DWN C. LACHALL	DATE 4/27/90	PROD ASSUR Q Meyer	DATE 90-08-20	BOEING VERTOL COMPANY DCN	DRAWING CHANGE NOTICE 77272	CODE IDENT. NO. DWG NO. 145G0076			
CHK W. AYMEN	5-8-90	WT				SH REV DWG 1 OF 8 B SH			
ENGR M. Junchak	RTC 8/9/90	MAT'L & PROC		REASON UPDATE DWG AFTER SUCCESSFUL FIT & FUNCTION DEMONSTRATION & MAKE REVISIONS TO IMPROVE OPERATION OF TOOL.		MODEL/ITEM NO. 414-100 / PIN CH-47D / 26300			
STRUCT		ORG G. Kengel	8-17-90	CODE D.IMP	CHANGE NO. WR6352 X				
PROJ S. Dunn	8/21/90	CUST P. McLaugh	8-28-90	ORIGIN GSE 7931	CLASS PER MIL-STD-480 <input type="checkbox"/> CLASS I <input checked="" type="checkbox"/> CLASS II	SPARES AFFECTED <input checked="" type="checkbox"/> YES <input type="checkbox"/> NO 8/23/90			
PL SH/ZONE	REPLACES QTY REQ'D	CODE IDENT	PART OR IDENTIFYING NO.	NOMENCLATURE OR DESCRIPTION	ZONE	MATERIAL AND SPECIFICATION	HT TR	FINISH	PT MK

PART I = NEW CHANGES

ENGINEERING DRAWING CHANGE CONTINUATION SHEET

(408) WORK STOP
(HALF SIZE) - 1 REQ.

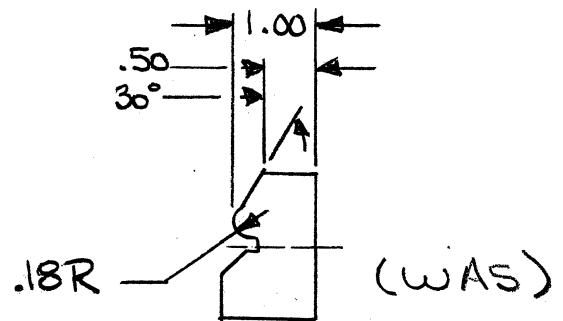
SH 4, ZN B-8
REVISED - 408 DETAIL

SH 4, ZN C-7
DELETED - 415 DETAIL

-415
ALTER AS
SHOWN

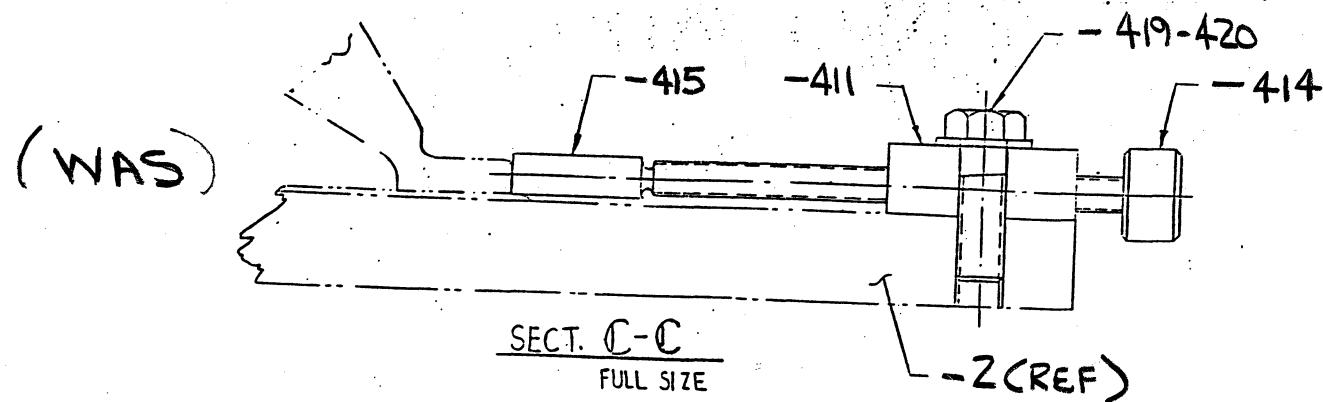
SH 4, ZN D-7, DELETED SECT. C-C

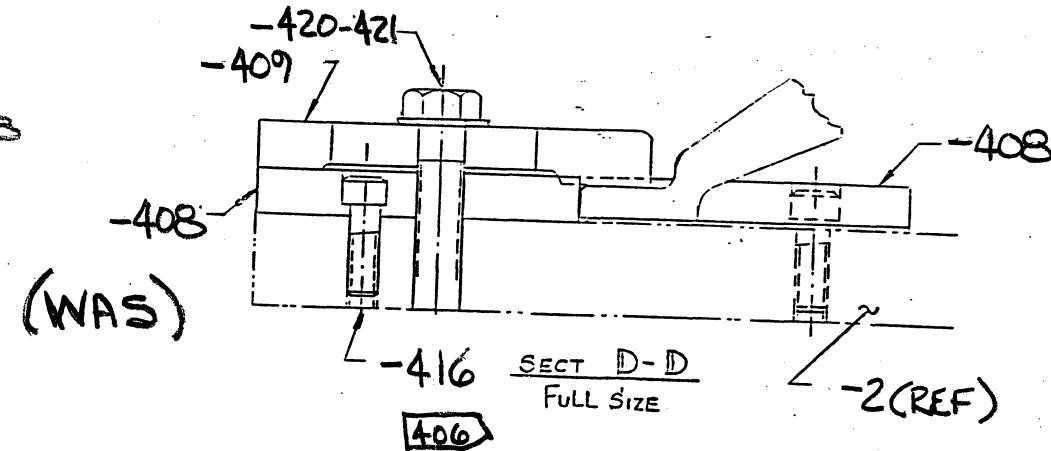
SH 4, ZN C-7
REVISED VIEW OF -408
IN SECT. D-D

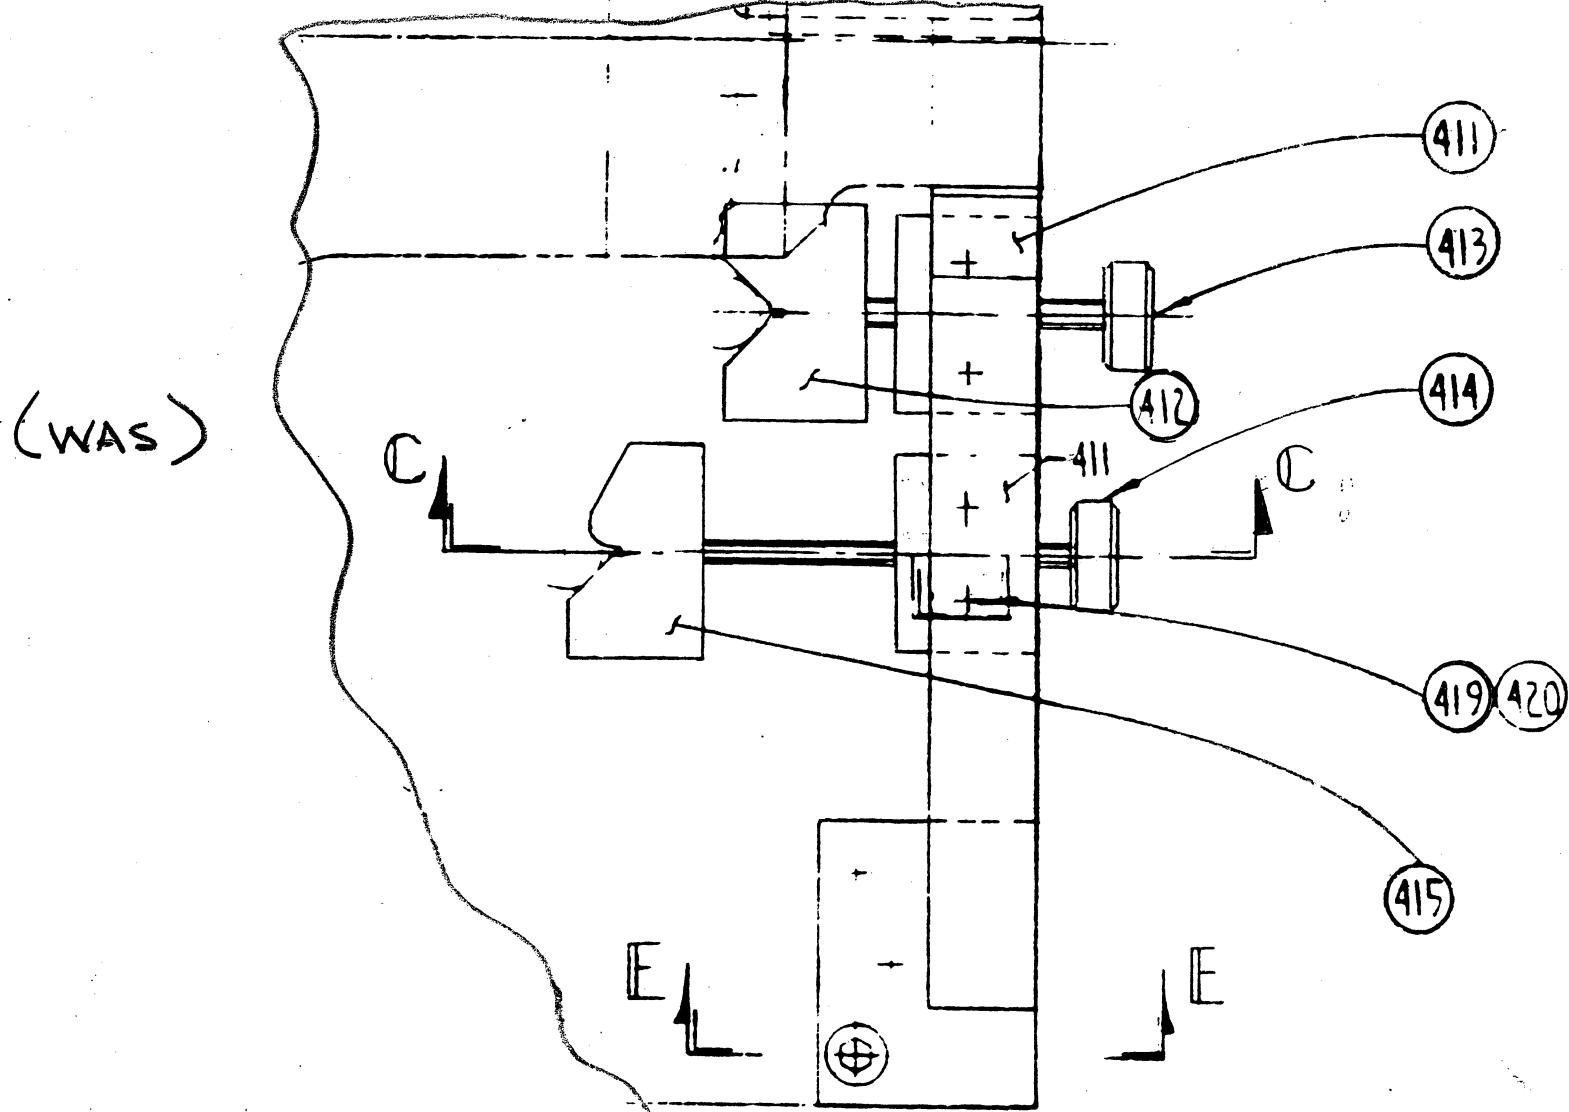
SH4, ZONES C-5 & C-6, DELETED FROM TOP VIEW OF -401 ASSY
DETAILS NOS -411 THRU - 415 & SECT "C-C".

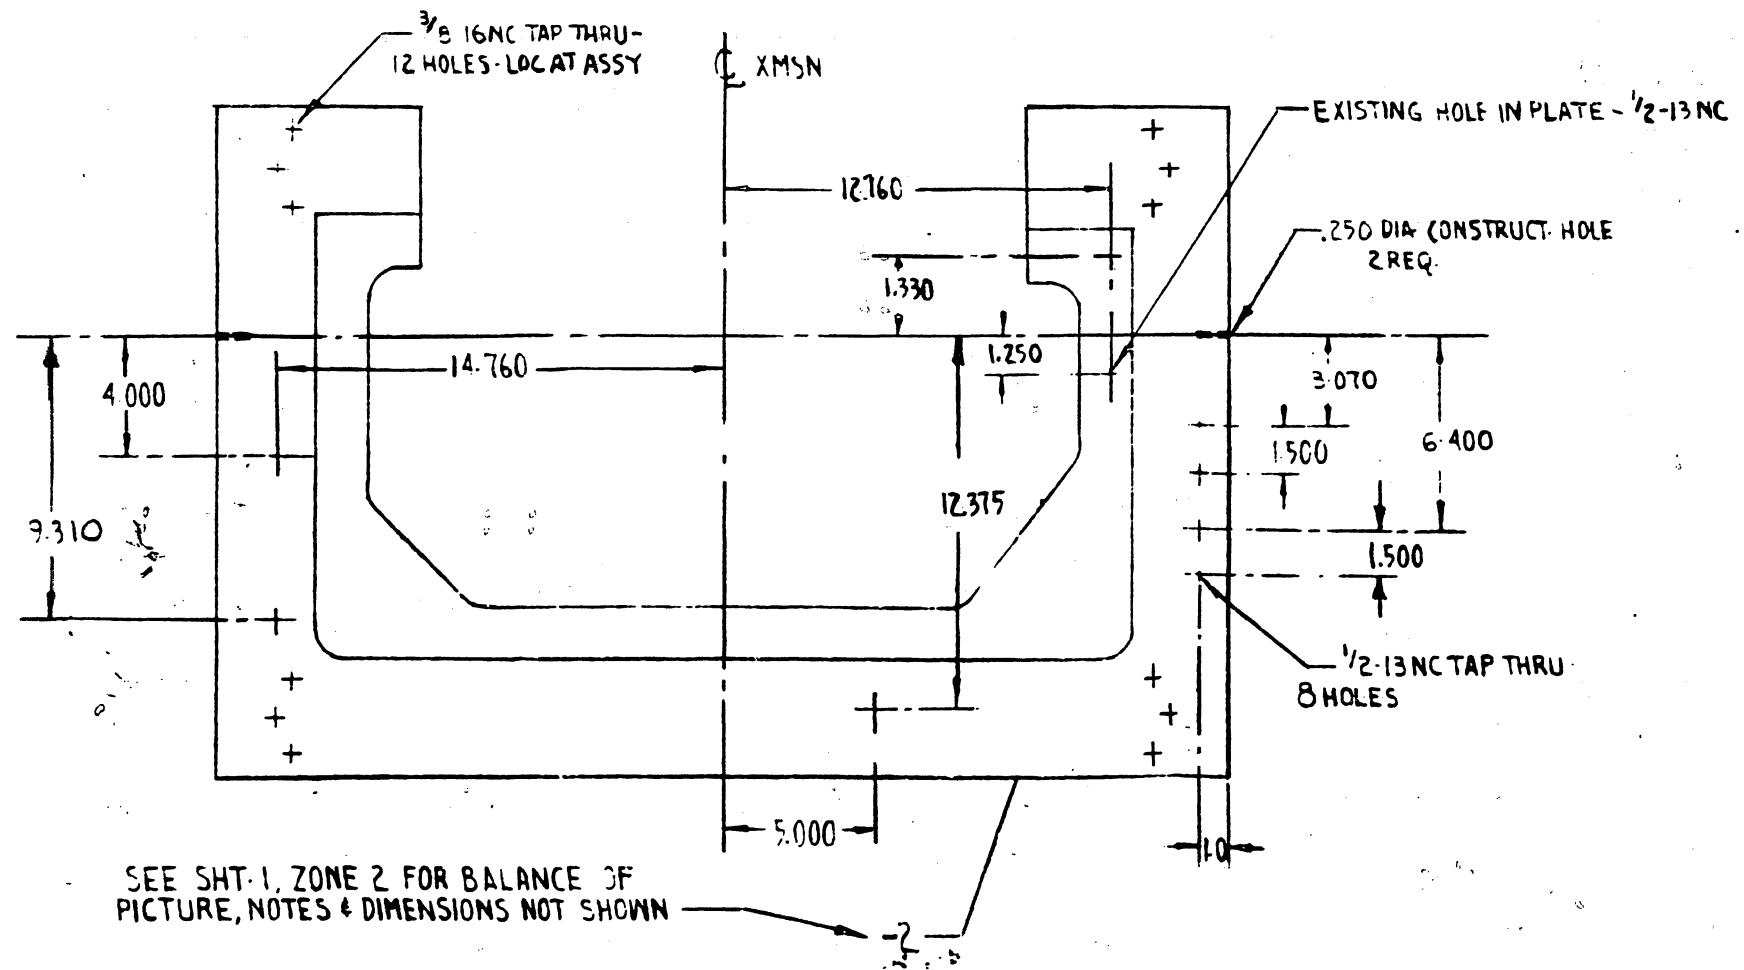
SH 4, ZONE B-7 REVISED HOLES FOR-2 BASE

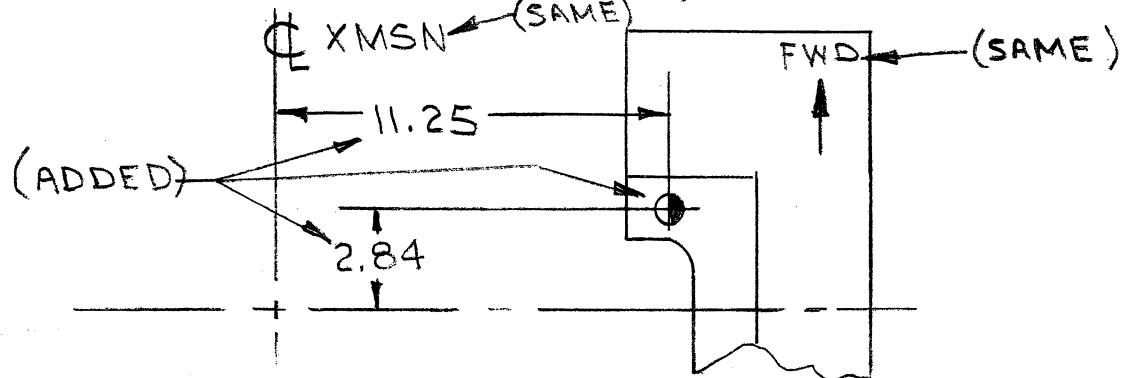
SH 1, ZN A-3, TO -2 BASE ADDED HOLE & DIMS AS SHOWN:

SH 4, ZONE A-8
ADDED CALL-OUT TO -40

SH 4, ZONE A-8
ADDED CALL-OUT TO -410

SH 1, ZN A-4, ON -2 BASE REVISED
CALL-OUT FOR .62 DIA HOLES

~~(DELETED)~~
(ADDED) .62 DIA DR THRU
7 PLCS
8

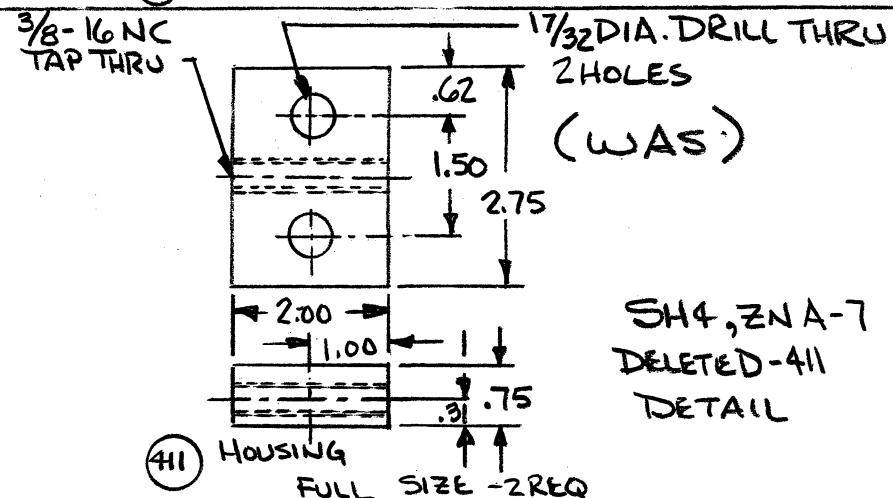
SH 1, ZN B-3, REVISED P/N OF
IDENT # IN CALL-OUTS

~~VS25113-4~~
BACN12MIWG

MS24630-4

~~VS25113-4~~
BACN12MIWG
(ADDED)
(DELETED)
